CMB Meeting Minutes #173

SUBJECT: Configuration Management Board Meeting # 173 – Rev. No. 0

Subject: **Proposed Contract Change (PCC#002) – Proposed Scope and Cost – UMS Roof Decking Changes**

TITLE: Modification to UMS Roof Composite
PROJECT: Stations, Surface, Track & Systems
TO: Attn: Patrick Jennings
Tutor Perini Corp
15901 Olden Street
Sylmar, CA 91342
Phone: 510-665-3114

TYPICAL ROOF DECK SLAB DETAIL
SCALE 1/2" = 1'-0"

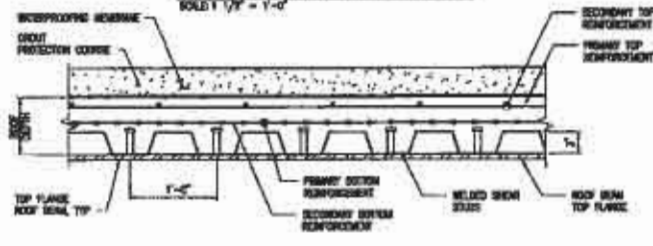
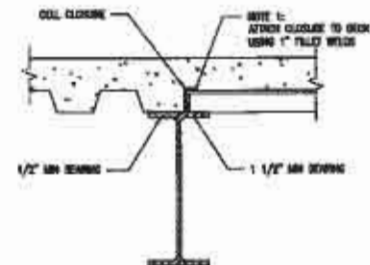
ITEM #	DISCUSSION	ACTION BY DUE DATE
1-	S. Tisell and R. Redmond presented the Contractor’s lump sum proposal for PCC 02 UMS Roof Decking changes. The Contractor submitted two options for consideration. Option A - would eliminate the 3" metal deck -16 gauge and adding the 2" metal deck -18 gauge, the finish would add extra concrete for a total amount of \$37K. Option B - would maintain the base bid decking but would increase the stud length with 5" shear studs and eliminate the 3.5" shear studs for a total amount of \$14K, reimbursing SFMTA for the credit difference. The difference quoted is 10 cents vs 45 cents for the cost of the studs (see attached). The CMB agreed with merit for Option B and authorized the CM team to negotiate with the Contractor for a cost not to exceed 125% of the Engineer’s estimate.	
2-	M. Vilcheck presented for discussion CSDG’s memorandum to evaluate the potential to eliminate all compensation grouting at the Yerba Buena/ Moscone Station (YBM) as required in bid items 4 Compensation Grouting & bid item 31 Compensation Grouting Holes at (YBM) for the adjacent 2-story Olivet building which will be demolish to make way for a new 11-story hotel development. As shown in contract drawing BP-101 the TODCO building requires limited mitigation. The Designer is proposing compaction grouting as an alternative methodology for mitigating potential settlement impacts to the remaining unchanged TODCO building. The CMB suggested two separate letters be sent to the Contractor one notifying them of the deletion of the bid item due to the change in the situation after bid and a second letter retracting the PCC for a credit proposal.

Description of PCC: At UMS roof, replace 3" high, 16 gauge composite deck with 2" high, 18 gauge composite deck; overall slab thickness remains 6 inches. Alternatively, at UMS roof, replace 7/8" x 3 1/2" high studs with 7/8" x 5" high studs; overall slab thickness remains 6 inches. Contractor to price both options. SFMTA will issue CMod based on the most cost-effective option.

TPC provides herewith a lump sum cost proposal for Option "A" for this Proposed Contract Change in the (additive/~~deductive~~) amount of \$37,239.00 (Thirty Seven Thousand Two Hundred Thirty Nine and 00/100 Dollars) per the following scope:

TPC provides herewith a lump sum cost proposal for Option "B" for this Proposed Contract Change in the (additive/~~deductive~~) amount of \$14,336.00 (Fourteen Thousand Three Hundred Thirty Six and 00/100 Dollars) per the following scope:
